Service Bulletin

Subject: Float Switch Clip, Float Inspections & Troubleshooting

Models: FQG60T, FQG80T, FQG100T & FQG120T Touch Screen Fryers prior to 2509 serials (Aug. 2025 and earlier).

2/3/2026

Figure 6

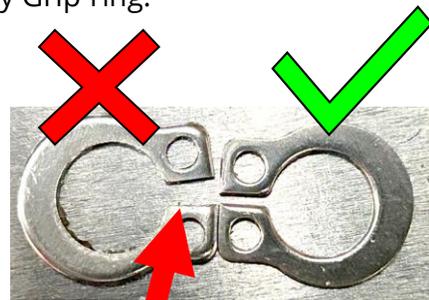
- ONLY HEAVY-DUTY GRIP RINGS** from the manufacturer (See Grip-ring on right in Figure 6) should be used. If grip rings are needed, order kit 8263865, which contains 9 (nine) grip rings. **GOOD** external Snap Ring pliers **will be required** to install the grip rings. Use care when installing the Grip-rings to ensure they aren't spread open (see Grip-ring image on the left in Figure 6).

Figure 7

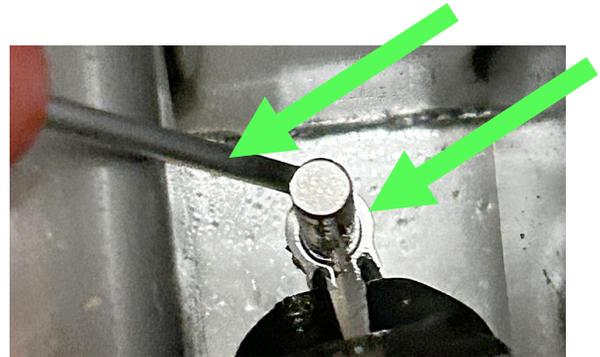
- If installing the bottom grip ring, a screwdriver will be needed to gently push the grip ring down into the groove while holding the grip ring with Snap Ring pliers (see Figure 7).

Figure 10

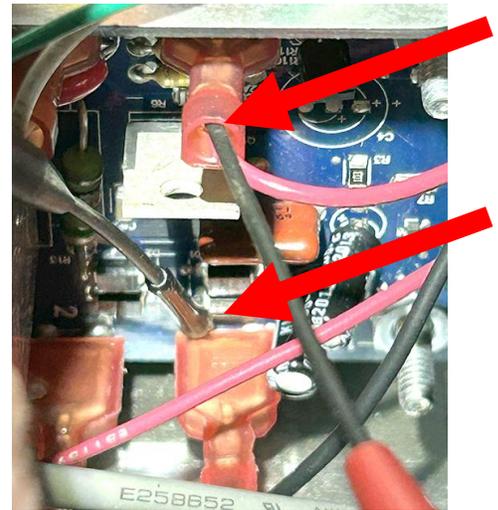
- a. With the float switch in the **UP** position:
 - i. Test **across pins** 8 (Red) & 1 (Black) (see Figures 10, 12 & 13). 24VDC should be present with the switch activated.
 - ii. Test **across pins** 6 (Green) & 7 (White) or 2 & 3, depending which pins have Green and White wires attached (see Figures 11, 12 & 13). The voltage should be near 0VDC when activated. If the voltage is above 0.3VDC with power on and contacts closed, the time delay relay **MUST** be replaced.
